**LEGAL ADVERTISEMENT
HISTORIC PRESERVATION BOARD
CITY OF PORTLAND
Public comments are taken at all meetings.**

**PUBLIC HEARING
71 INDIA STREET**

TO: Chair Benson and Members of the Historic Preservation Board
FROM: Deborah Andrews, Historic Preservation Program Manager
DATE: May 11, 2017
RE: May 17, 2017 **PUBLIC HEARING**

Application for: Certificate of Appropriateness for Building Addition
Address: 71 India Street, addition to existing Amato's store
Applicant: Dominic Reali Realty LLC.
Architect: Evan Carroll, Bild Architecture

ATT. 1A

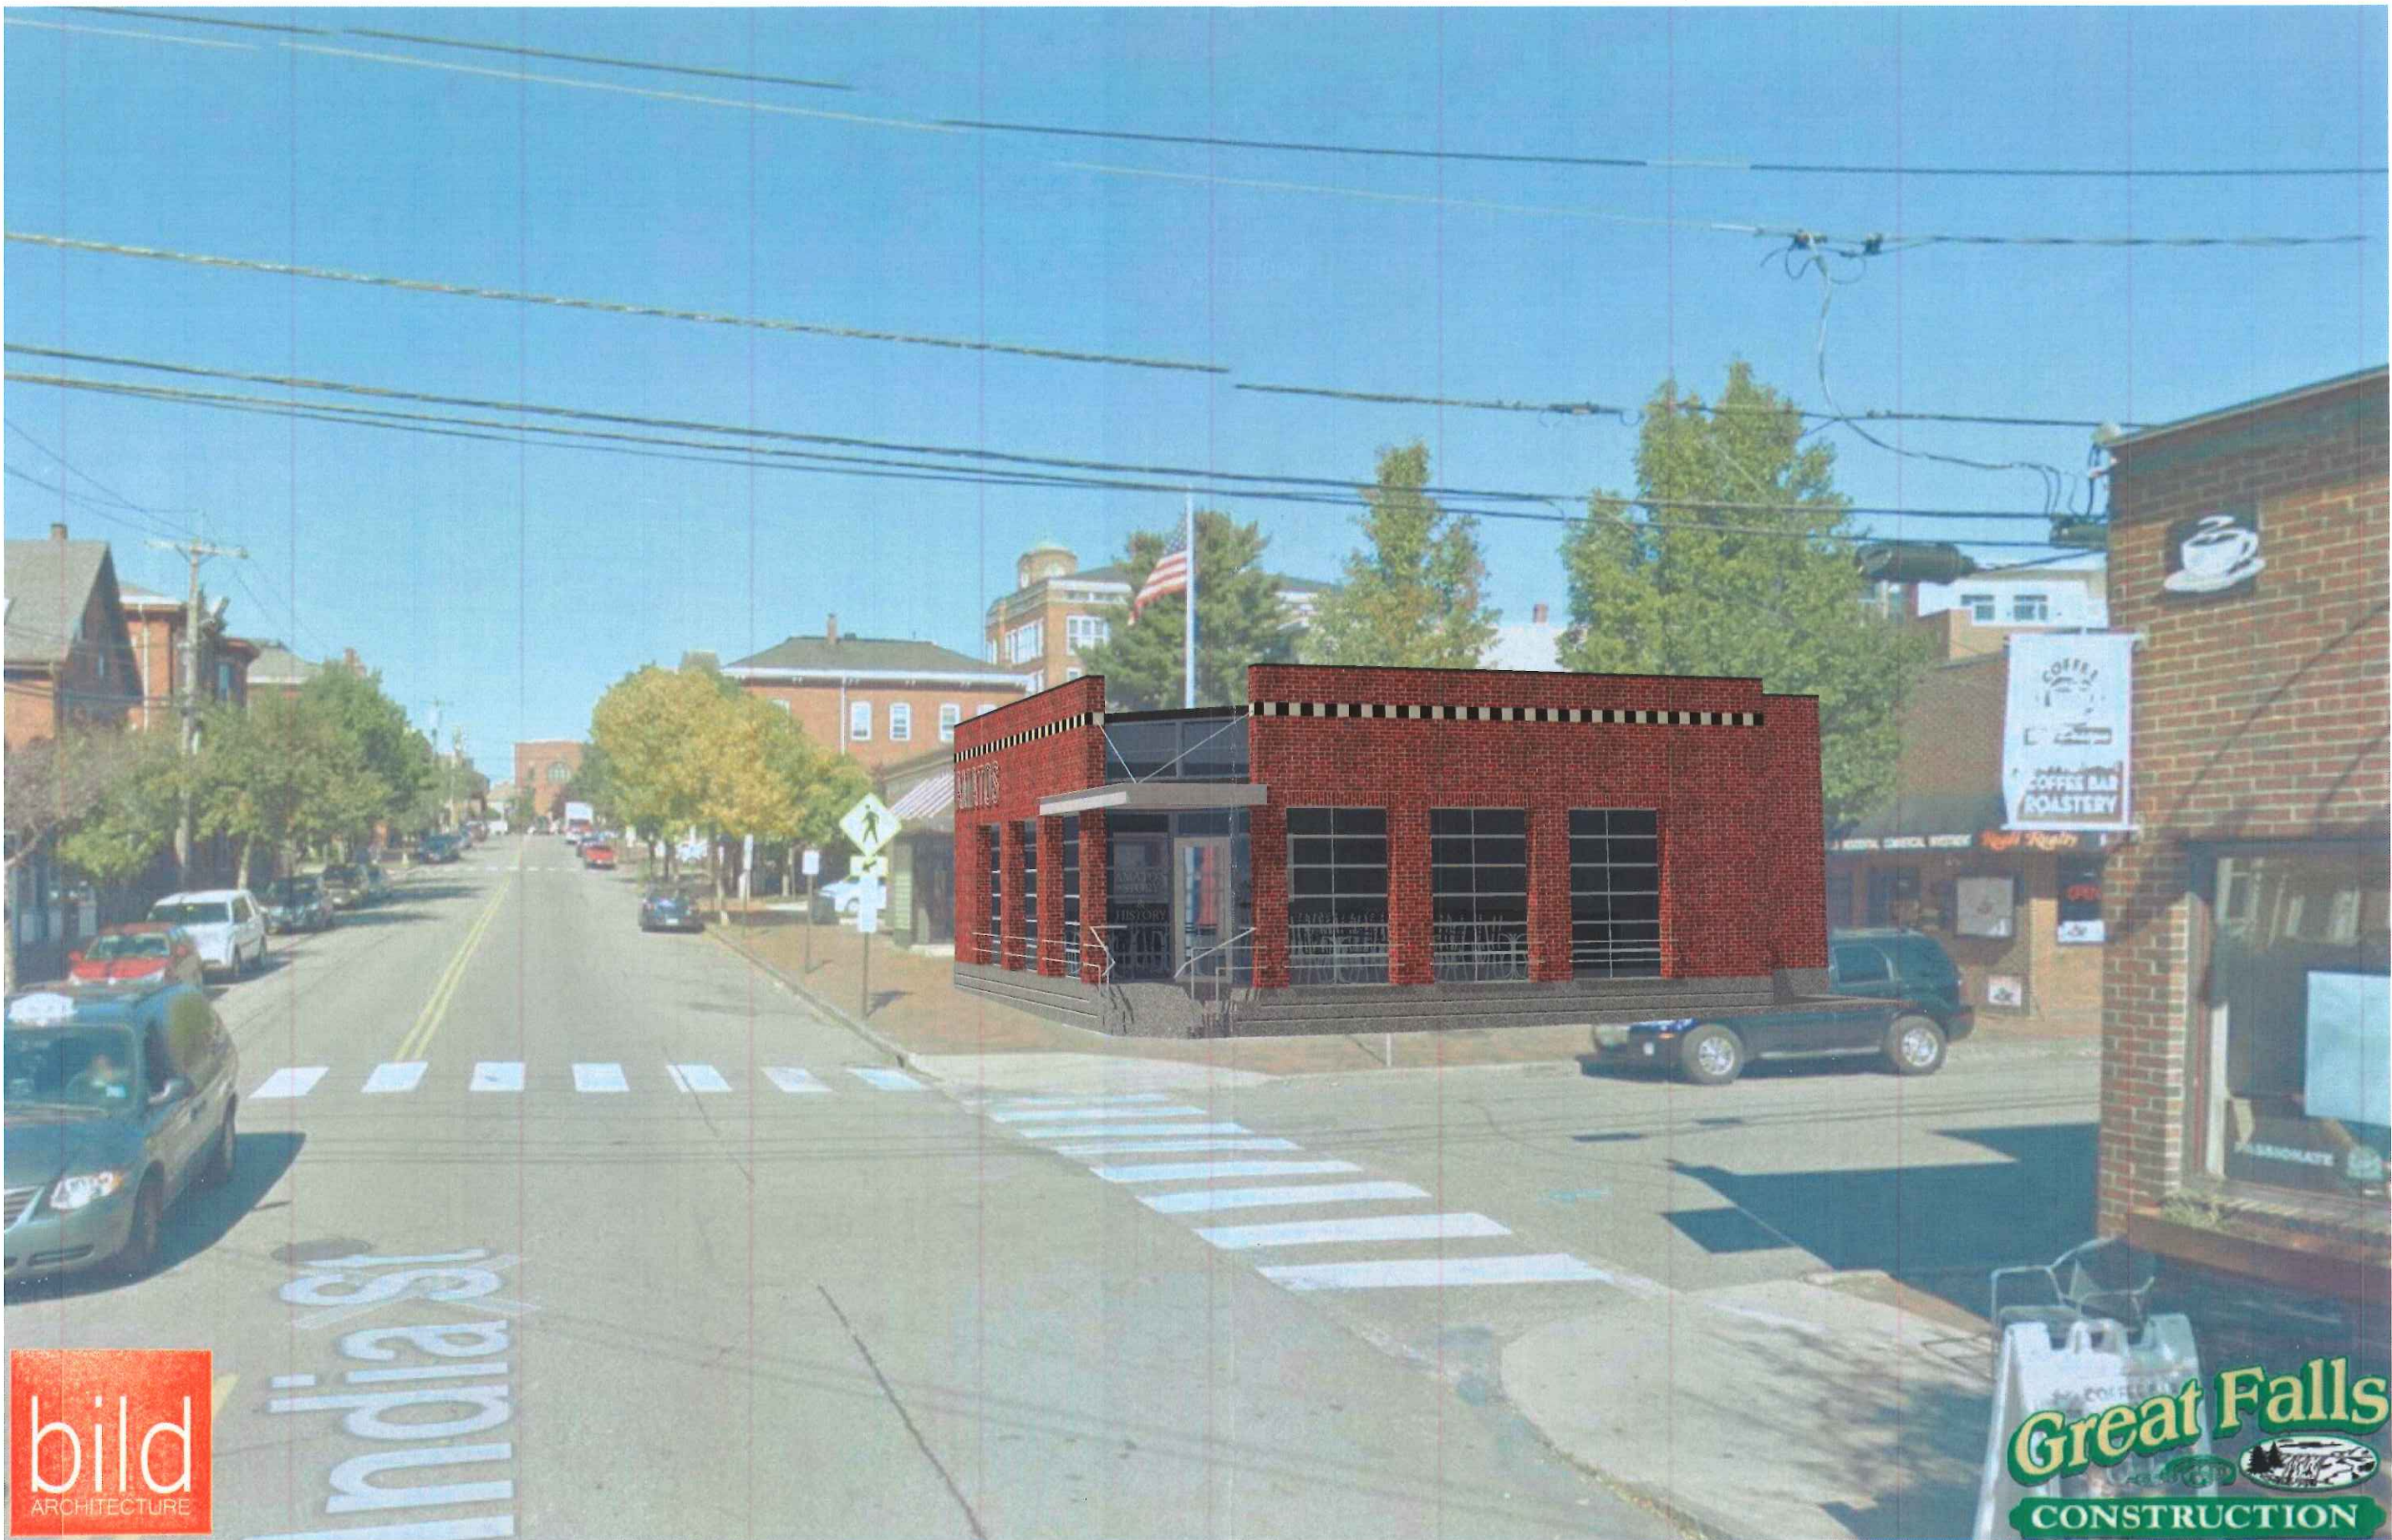
As Board members will recall, the design solution for the proposed building addition changed considerably following the first workshop in March. In response to expressed concerns about the scale of the proposed addition and its lack of architectural relationship to either the existing Amato's structure or its larger India Street context, Mr. Carroll revised the proposal in a number of significant ways. Under the revised scheme, the height of the addition was brought into line with that of the existing structure, the footprint was freed from the chamfered footprint of the existing garden retaining wall, the lantern-like rooftop element was eliminated and the design solution took a number of its visual cues from the building it will adjoin.

Board members responded very favorably to the new design direction, finding that it related much more successfully to its context and resulted in a more architecturally cohesive building complex. Board comments focused on contributing elements of the proposal, rather than the overall design solution. Details identified as warranting further consideration included the corner entrance treatment. Board member Turk noted that while the entrance read appropriately as viewed from a distance, the entry would likely feel constrained or "cage-like" as one actually entered or exited the building. Mr. Carroll was encouraged to consider design modifications to the entry to address this concern. The narrow wall planes that serve as the transitions between abutting structures and the new addition were also identified as warranting further study, particularly the wall between the store façade and the projecting dining room façade. Board members recommended that the transitional wall pick up on key datum lines established on the abutting elevation.

Board members expressed general support for the sign solution presented, which featured individual brushed aluminum letters. They found that although the scale of the letters was large, they were architecturally integrated with the building design and appropriate in this case. Mr. Carroll indicated that the signage might be further revised to feature the logo of the business on the Newbury Street elevation.

Board members noted that the brick selection would be important in this instance to ensure compatibility with the existing brick structure. They also noted that more detailed elevations and wall sections would be required for the public hearing, as well as specifications for the garage doors, exterior lights, etc.

Entrance: At the entrance the window divisions have been altered to be consistent with the real dimensions of the proposed overhead door product. The material for the underside of the canopy has been chosen and reflected in the model. In the previous design the entrance steps and railings got narrower as one descended. In the revised design, the railings stay the same width for the run of the stair, and the steps themselves now cascade down from smaller to larger. The suspension cables for the awning have been removed as they were not necessary and were not contributing to the concept. The entrance canopy will drain to the sidewalk, but the small amount of water will be diverted to either side of the entrance. The graphic displays beneath the canopy will be lit by the attached fixture, mounted to the underside of the canopy.

India Street Elevation: The brick now starts at the existing footing wall, with the new concrete slab poured on either side for the brick. This helps the building to feel more grounded. The overhead doors have been revised to reflect the specifies overhead doors. The railings in front of the overhead doors have not moved, but now align more effectively with the doors.

Newbury Street Elevation: In addition to the same changes as India Street, one of the overhead door bays has been removed to allow the installation of the Amato's tomato graphic. The graphic will be fabricated out of aluminum stock just as the Amato's text on India Street. Both the text and the graphic will be lit from above by an external fixture. See specification sheet attached.

Elevation end walls: The finishes on the elevation end walls now continue down to the level of the existing foundation, emphasizing the "light touch" connection between the existing and proposed portions of the building. The spandrel material has been specified as a folded light gauge metal to emphasize the light connection. Lastly the end walls have been recessed so that they are clearly secondary to the two walls they are connecting.

ATTACHMENT 1

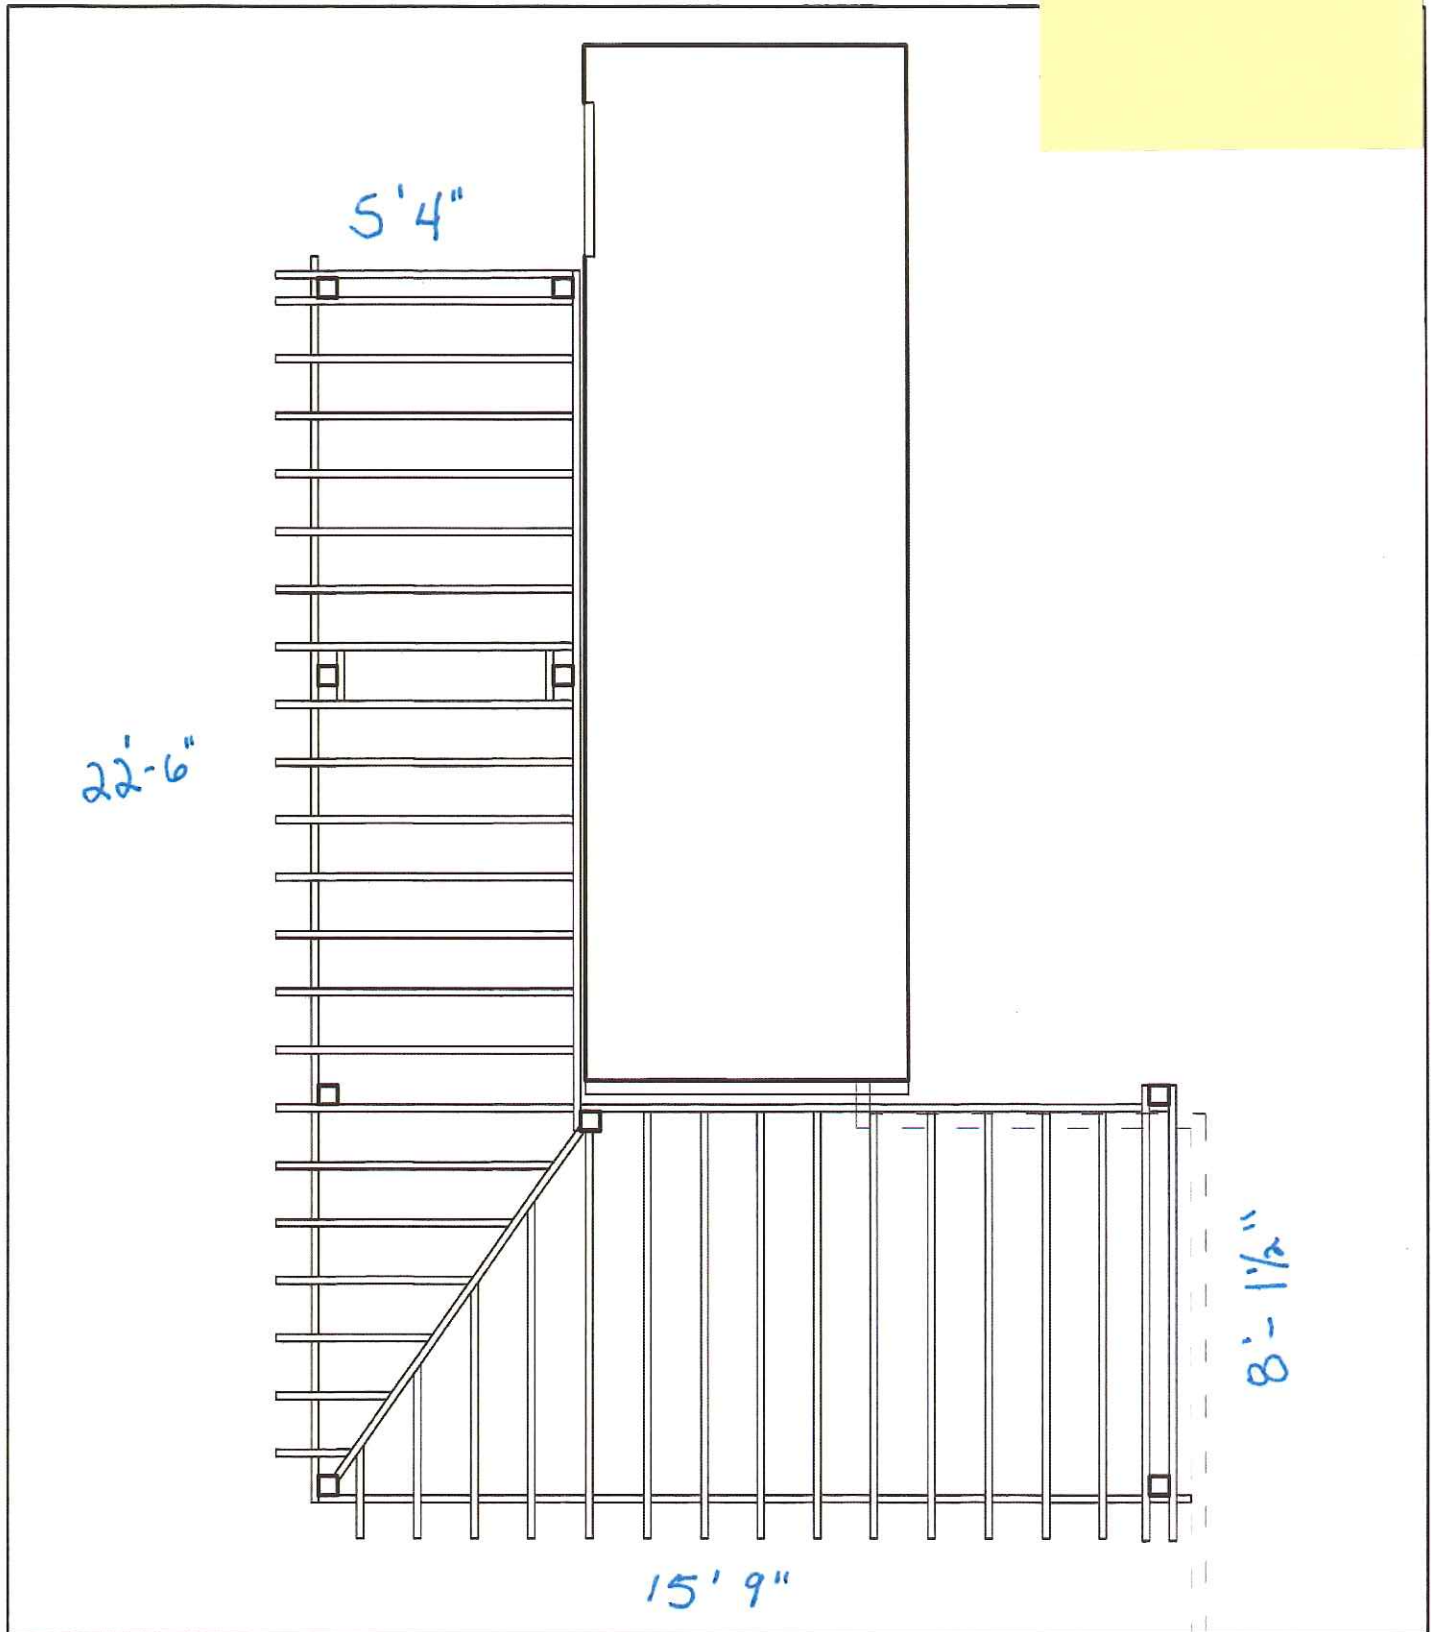
protection from hot sun, but believes the scale and visual impact of the pergola unfortunately present just the sort of distraction the Board and the architect tried to avoid in the final approved plan. If Board members do not find the recently added pergola consistent with applicable standards, perhaps they can make suggestions for more modest or temporary protection from the sun. In regards to the proposed planters, staff wonders if low planters positioned in the middle of the deck, some distance in from the railings would not be visible and thus avoid causing visual clutter.

ATTACHMENT 3

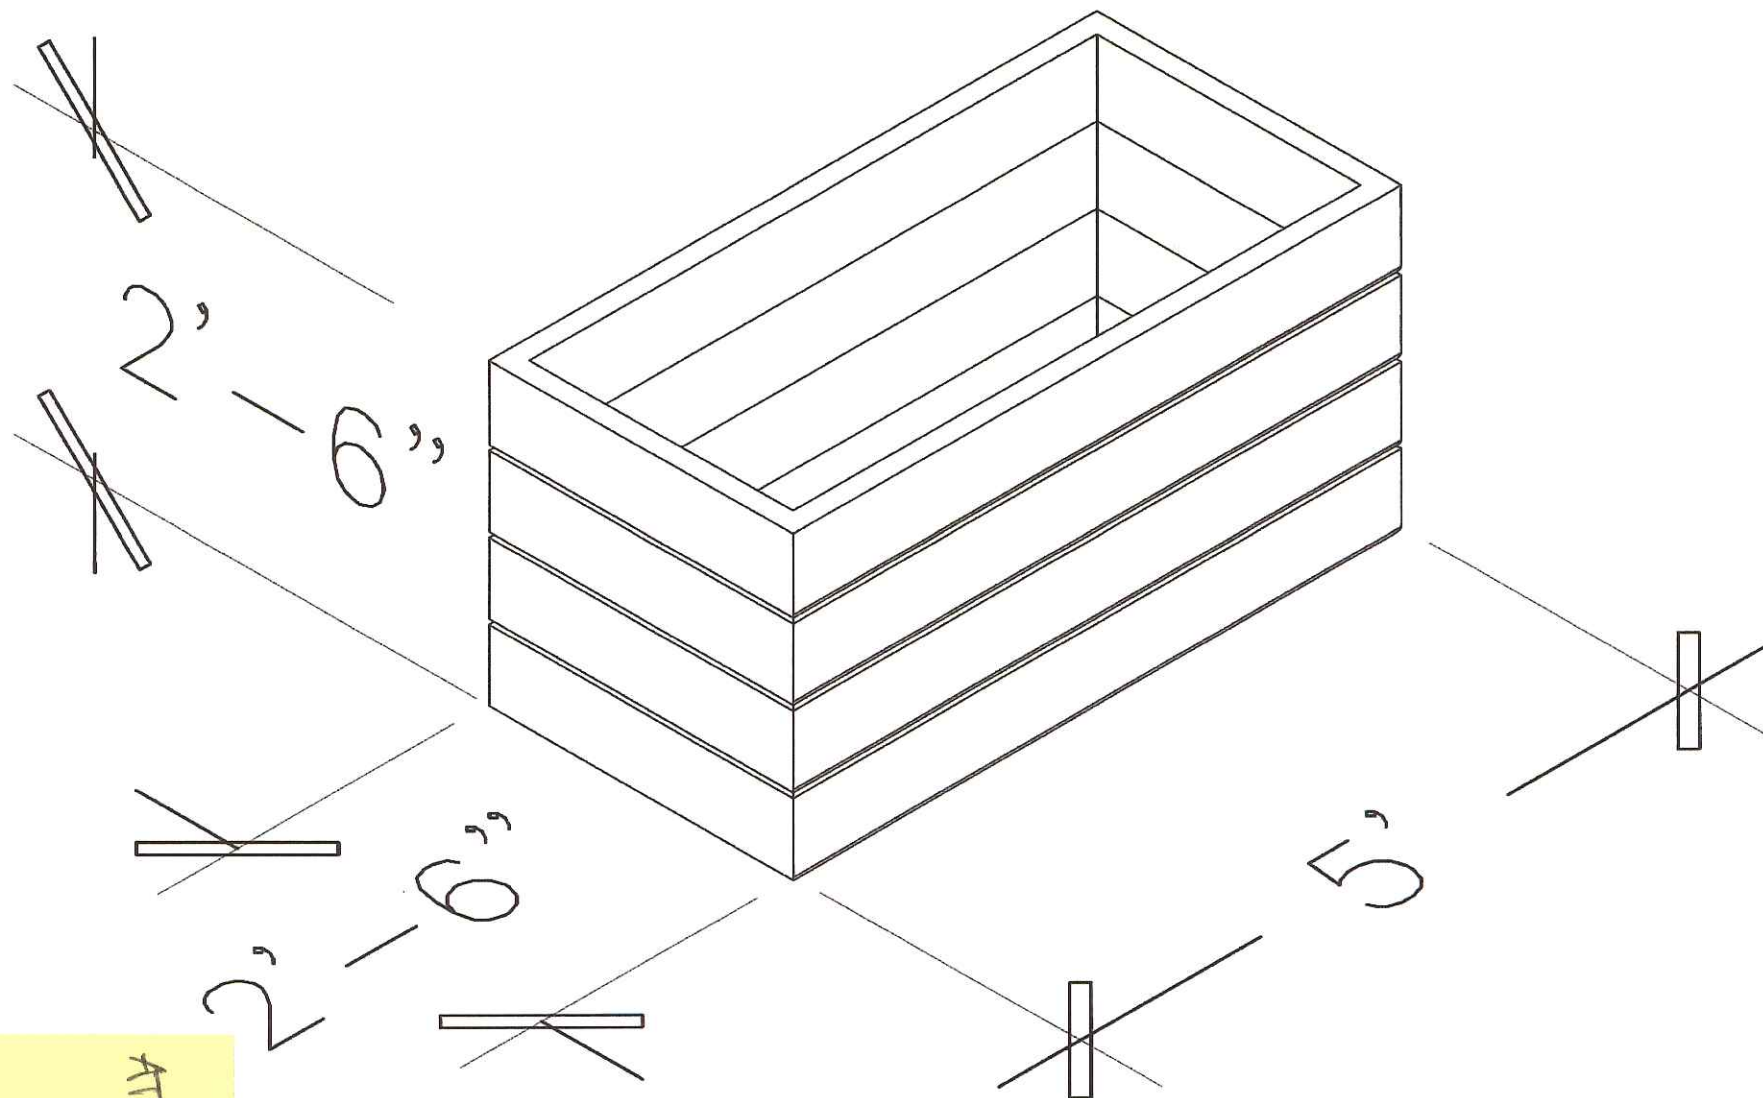
- Planter to be painted identical to 5th floor exterior color
- ~~Planter will be secured to decking with screw-down blocking.~~
- Planter to be constructed of composite materials to prevent decay
